CONVAIR

COMMERCIAL CHANGE PROPOSAL

SPEC NO.: ZD-22-327

CUSTOMER: JAL

PILOT'S AND CO-PILOT'S PEDESTAL
JAPAN
(EFFECTIVE SHIPS 1, 2 AND 3)

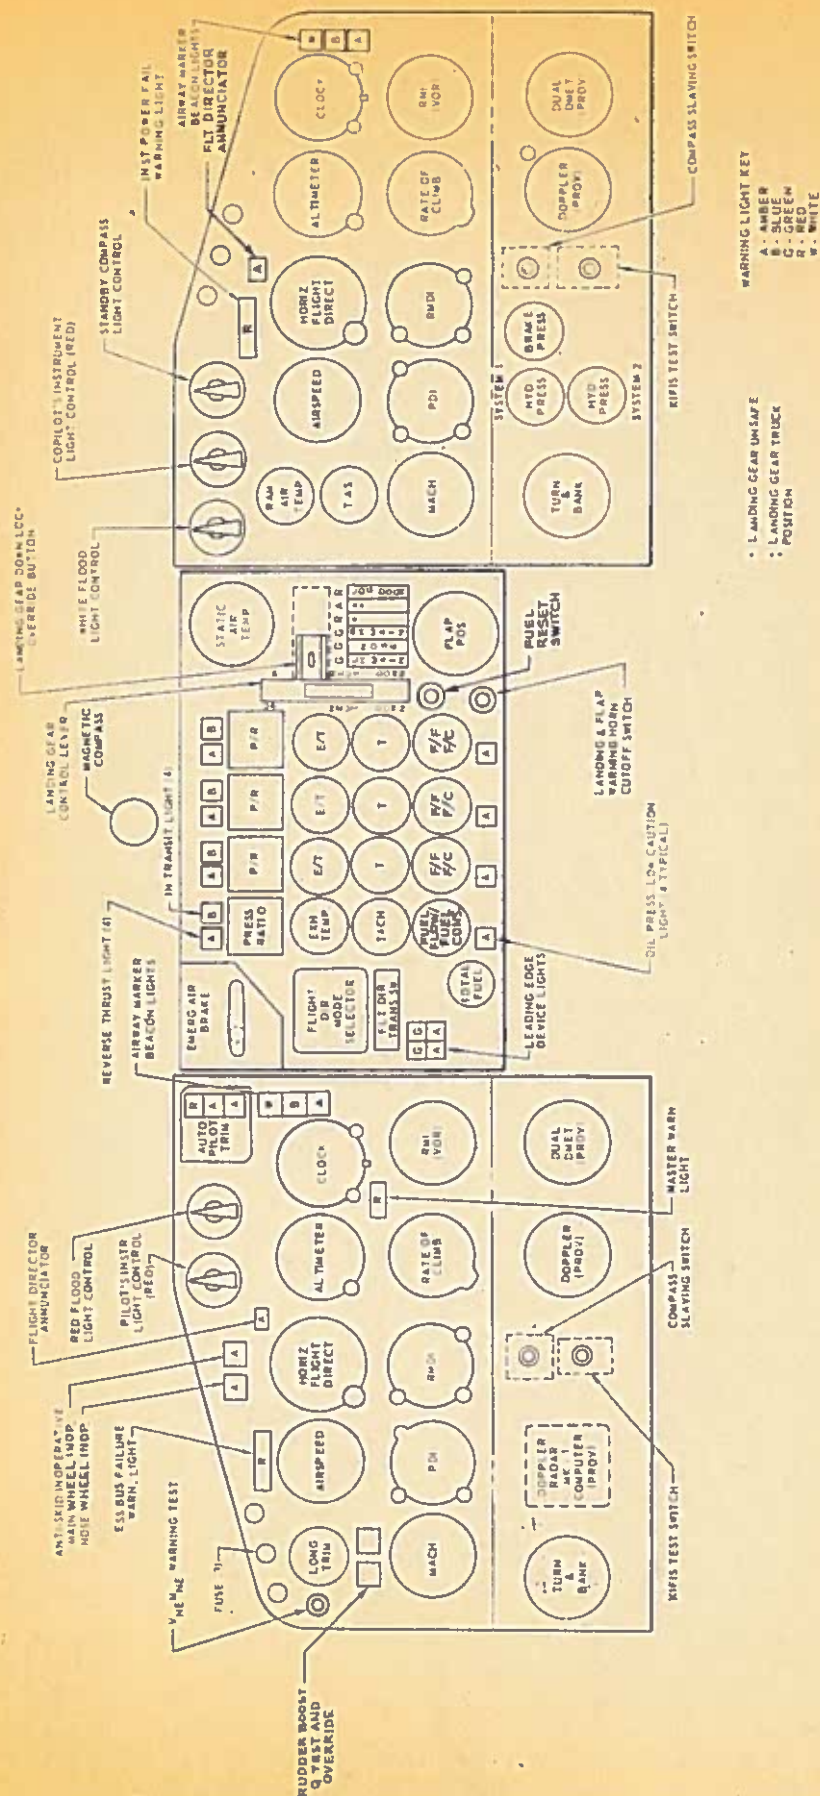
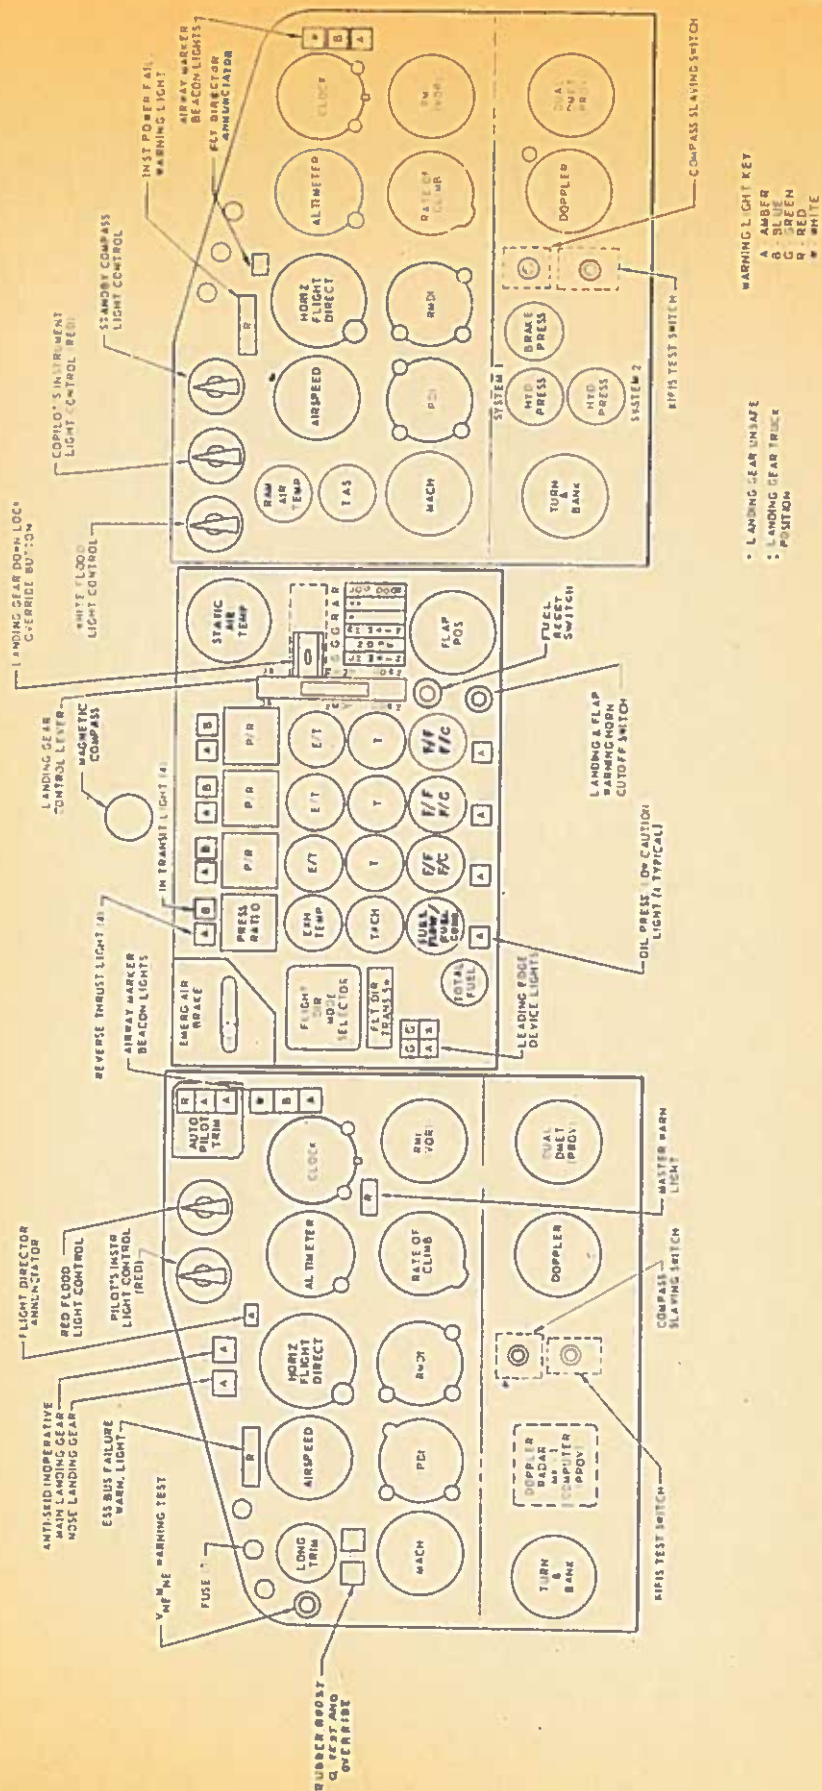
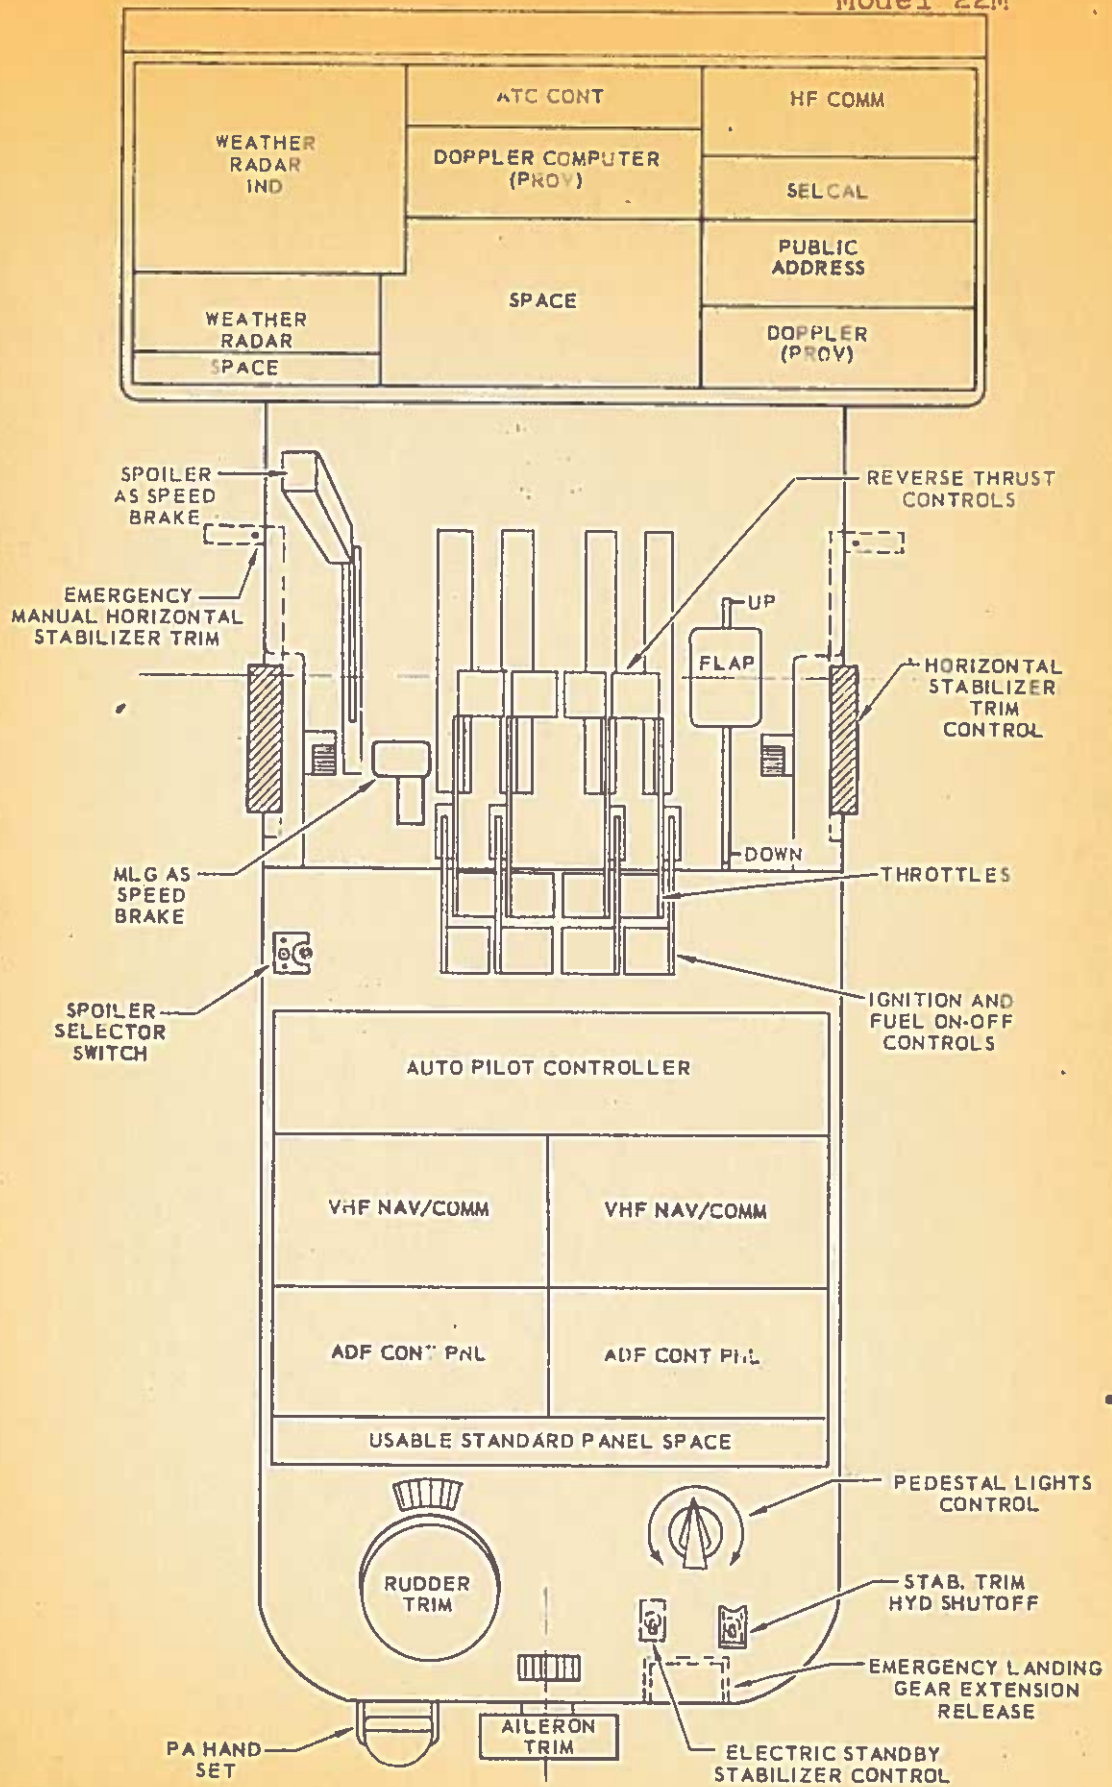
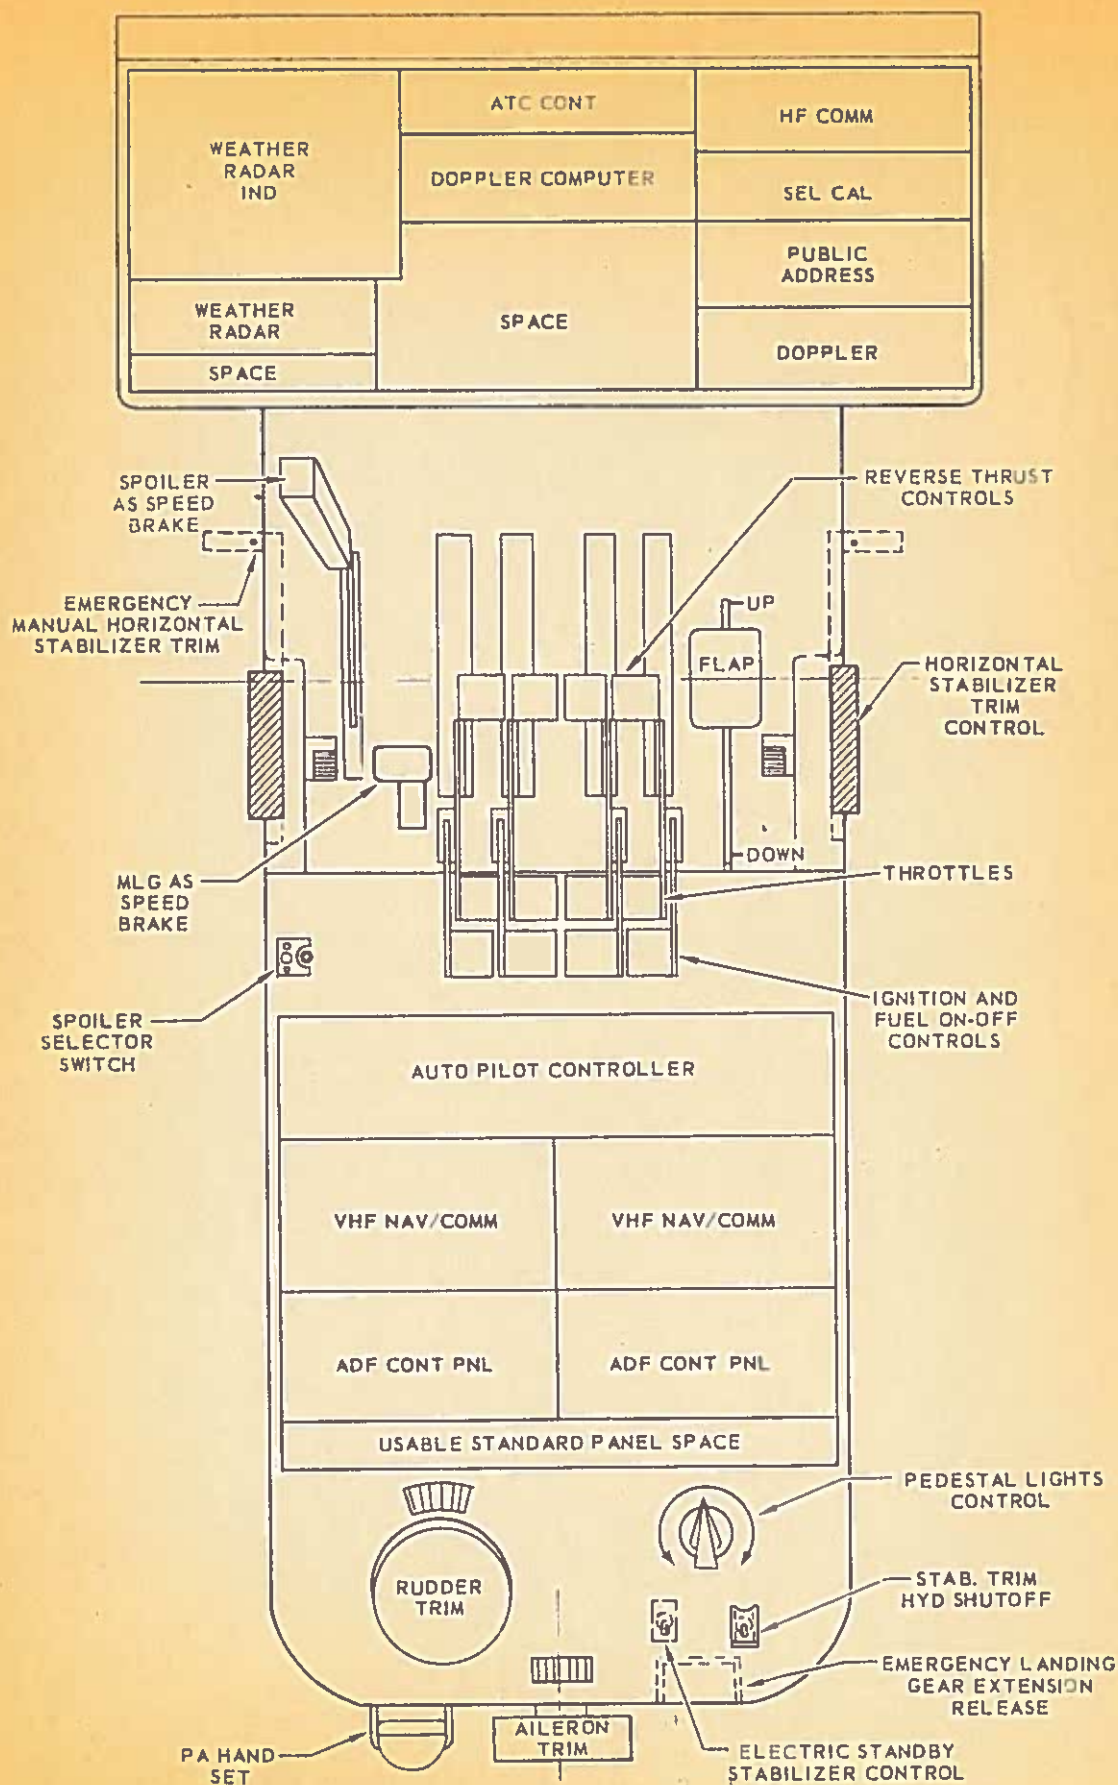
Revise above illustration to show ship effectivity 1, 2 and 3.

Add the above illustration which shall show ship effectivity 4 and 5, and the installation of Doppler indicator.

Revise above illustration to show ship effectivity 1, 2 and 3.

Add the above illustration which shall show ship effectivity 4 and 5, and the installation of a Doppler computer control panel.

PILOT'S AND COPILOT'S INSTRUMENT PANELS

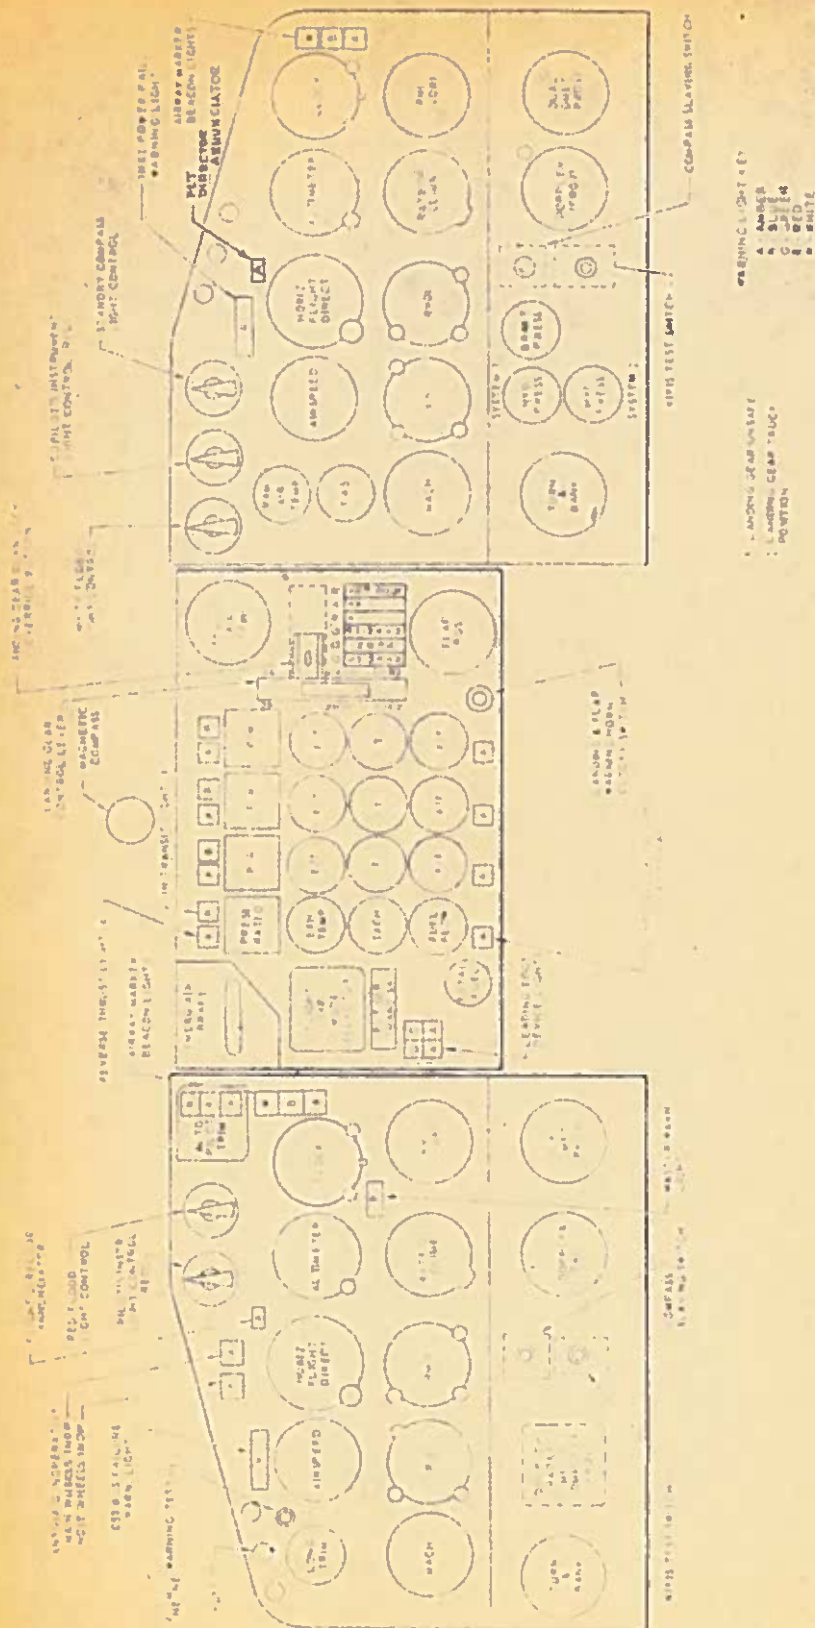
Replace above illustration in the specification with Enclosure (A) which deletes "MAIN LANDING GEAR" and "NOSE LANDING GEAR" on pilot's panel and adds "MAIN WHEEL INOP." and "NOSE WHEEL INOP."

PILOT'S AND CO-PILOT'S PEDESTAL

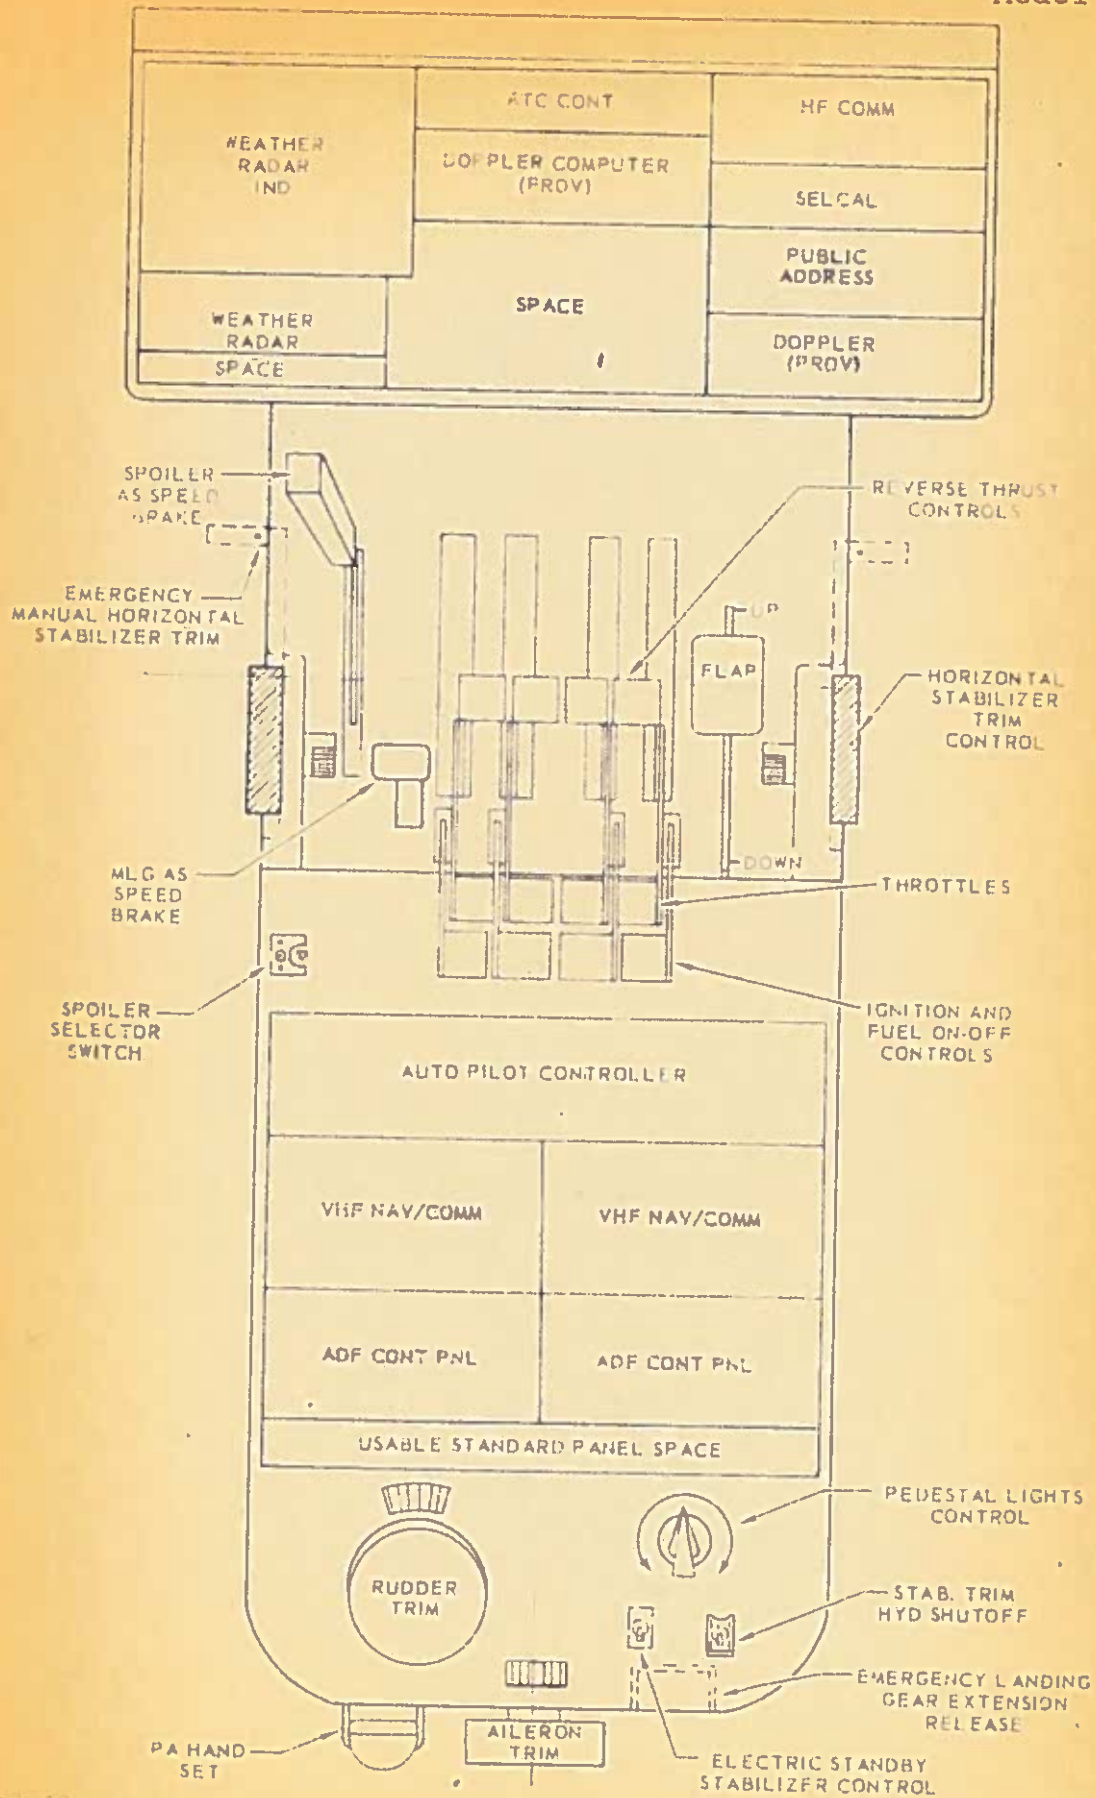
Replace above illustration in the specification with Enclosure (B), which deletes "MALFUNCTION LIGHTS".
